City of Quincy, Massachusetts  
Purchasing Department  
1305 Hancock Street  
Quincy, MA 02169

## **ADDENDUM NUMBER 1**

**BID/RFP TITLE: RENOVATIONS & RECONSTRUCTION AT SAFFORD PARK**

ADA WELDED TWO LINE PIPE RAIL

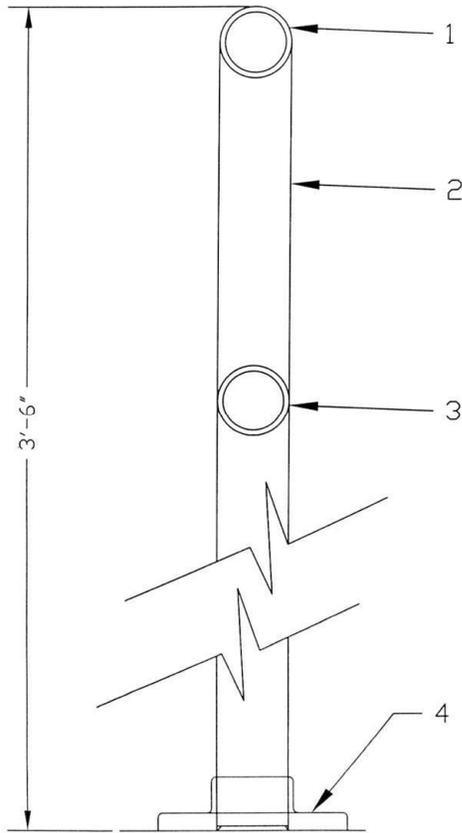
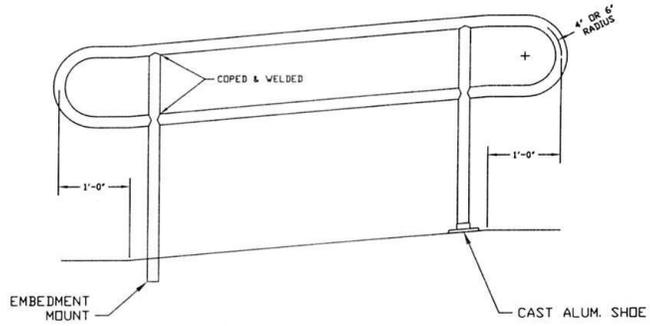
**Question 3)** We are looking for detail drawings showing depth and diameter of handicap railing footings.

**Question 5)** Is there a detail for spacing on upper and lower bar on handicap railings, and what is the diameter and schedule of pipe?

***ANSWER: 3) I have attached a section and elevation of an ADA code compliant railing for bidder's reference. Note all bidders should verify the latest code to guarantee that installed ramp is to ADA's latest code. The style of railing should be adopted for the handrail at the two sets of steps.***

***ANSWER: 5) See answer to question 3 above.***

PLAN: GRADING AT ADA RAMP.

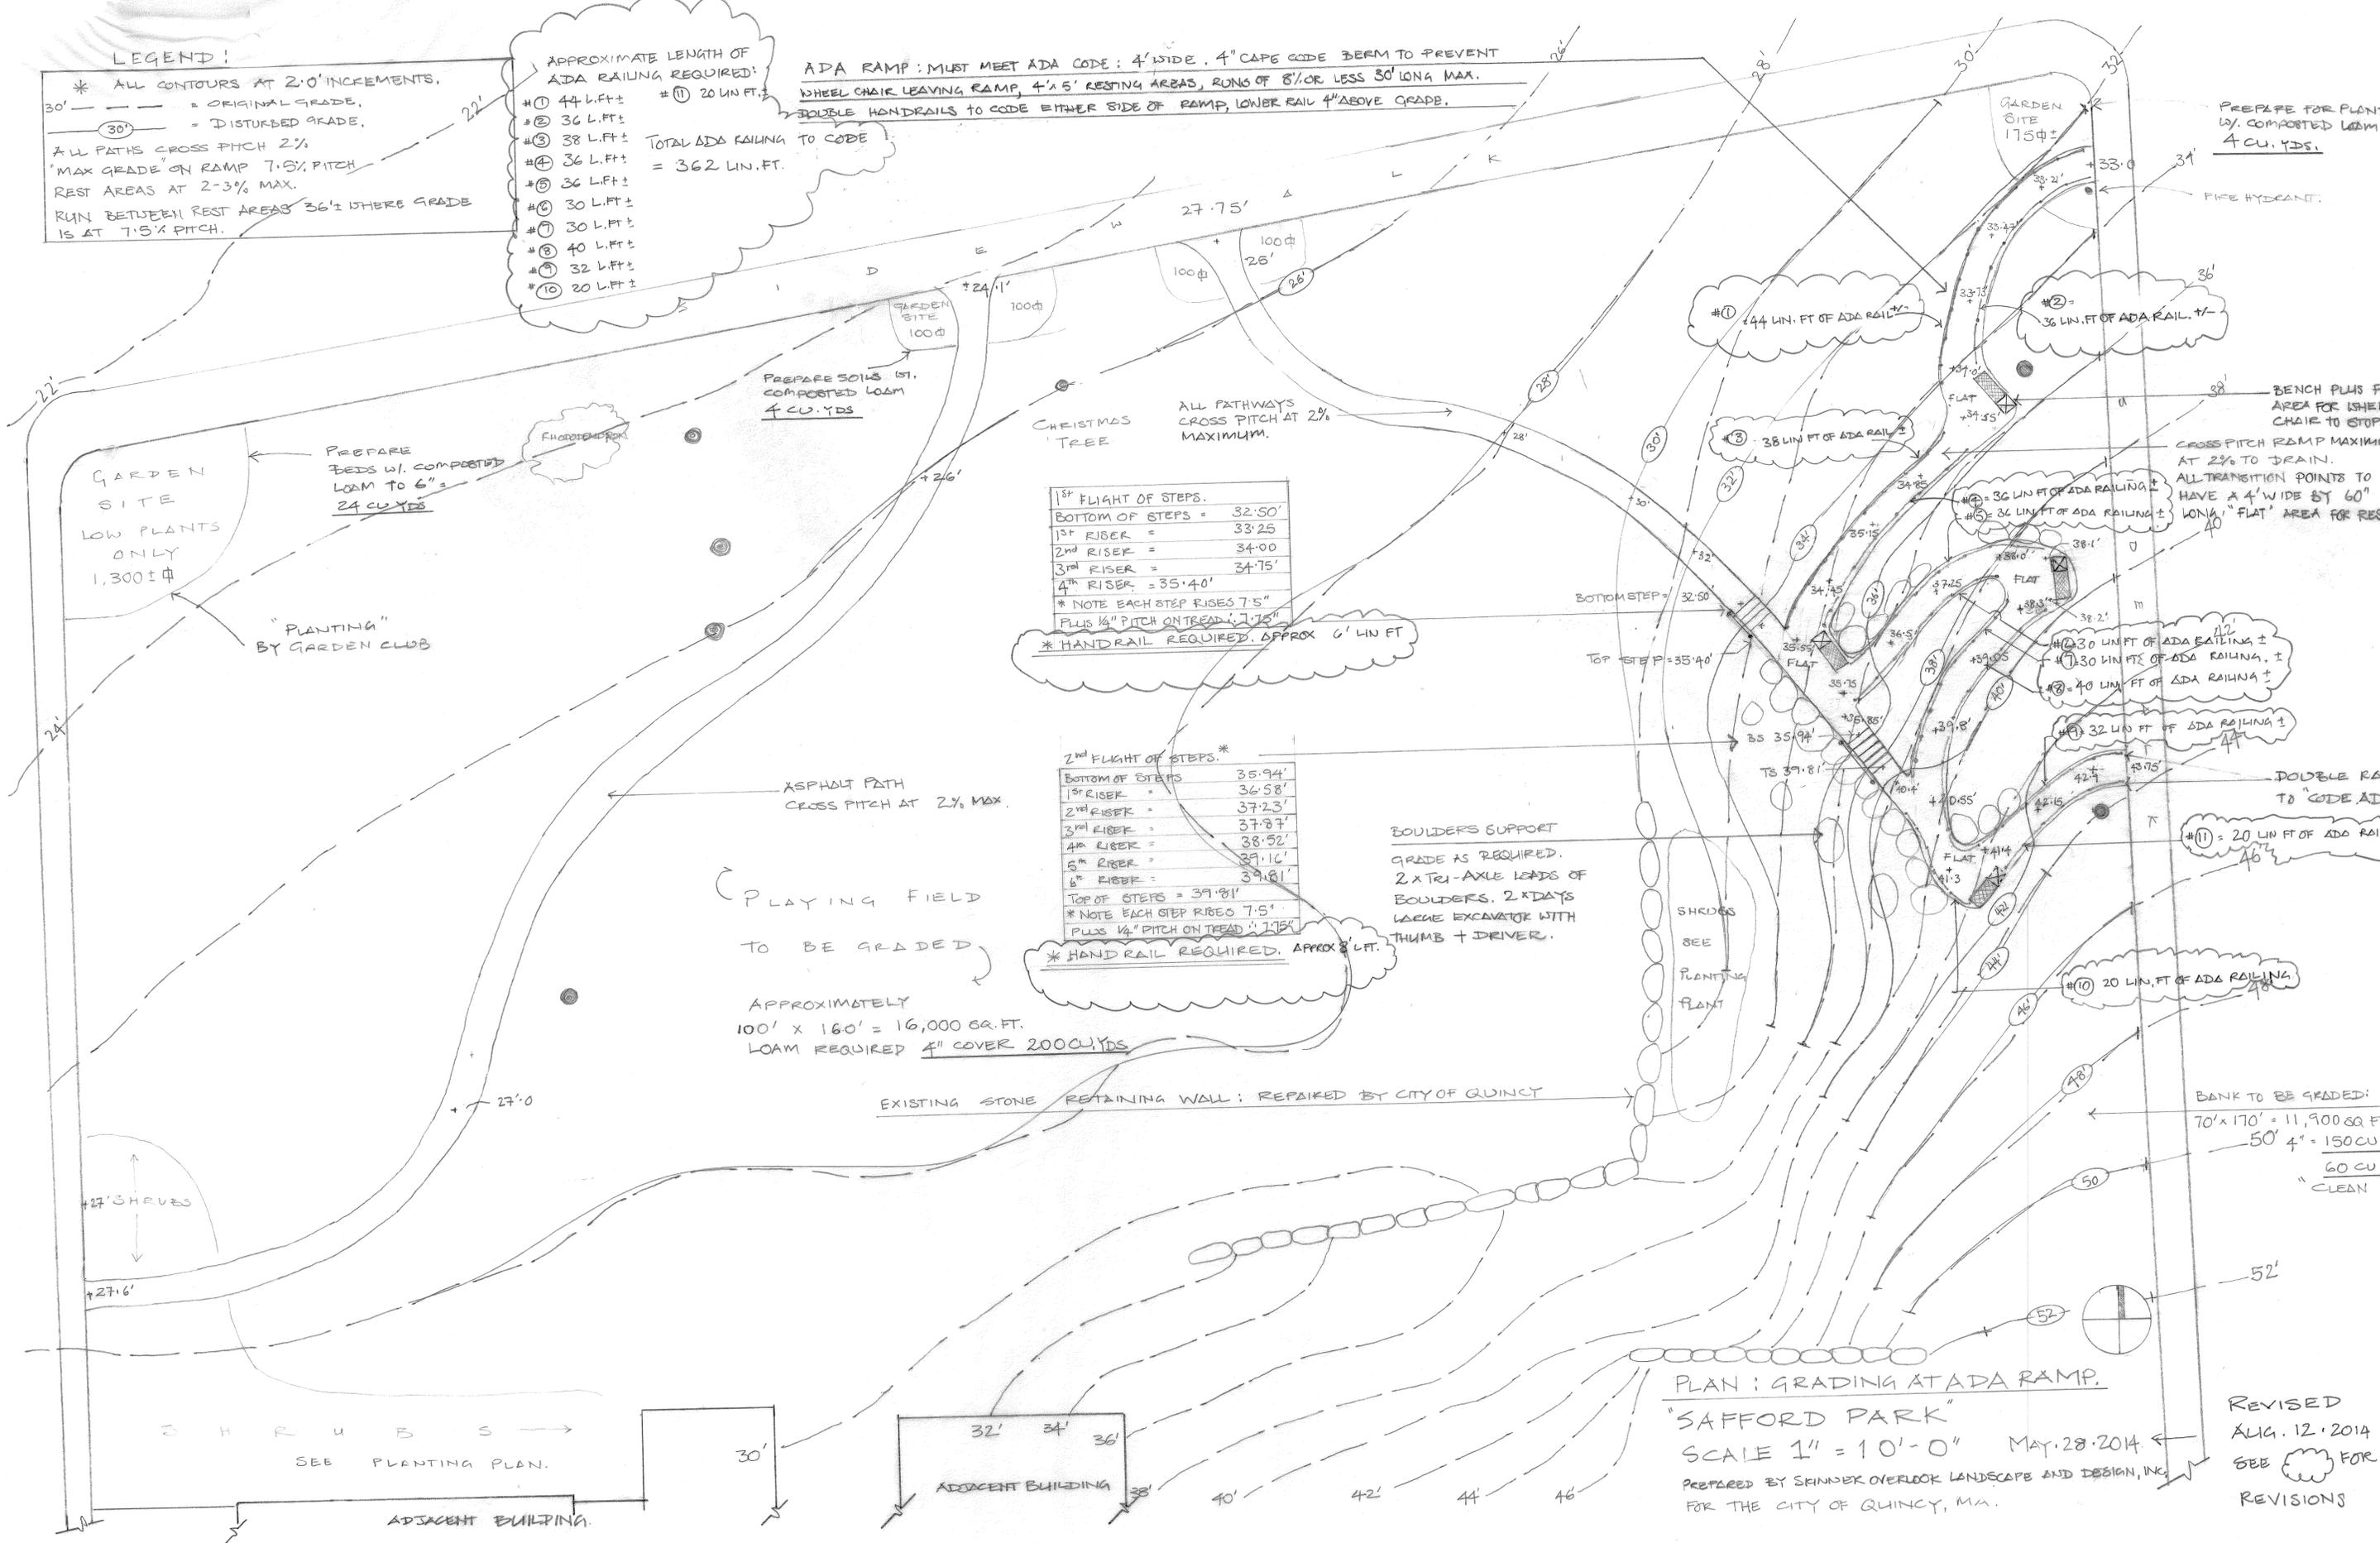
**Question 1)** There are different drawings showing the handicap access, which would be the correct one to use? One of them goes to Beale St, the other goes to Winthrop.

**Question 2)** Which drawing would indicate the total length of the handicap railings needed for the project?

**Question 6)** There is a discrepancy between the spec and the drawing in regards to riser height, page 5 states 7.5 " riser, and the plan calls for a 6" riser. Please clarify.

**Question 12)** On page 6 of the specs it says asphalt walkway to be 5' wide, one of the drawings states 4' wide, please clarify.

***ANSWER: 1) The drawing the bidder should be looking at is dated May 28, 2014 and titled "Plan: Grading at ADA ramp", the down hill exit of the ramp is at Winthrop St. just above the junction with Beale St.***

***ANSWER: 2) The same drawing as number 1) the approximate length of the railing shown on the plan is 362 linear feet. NOTE: The steps require a railing set too. Use ADA railing detail attached as a construction guide. The lower steps require 1 railing of approximately 6 linear feet. The upper steps require a railing of approximately 8 linear feet.***

**ANSWER: 6)** *The correct riser height is as shown on the plan of May 28, 2014 calling for a 7.5" riser plus the pitch on the steps for a total of 7.75"*

**ANSWER: 12)** *ALL pathways, steps, and ramps should be 4' wide only.*
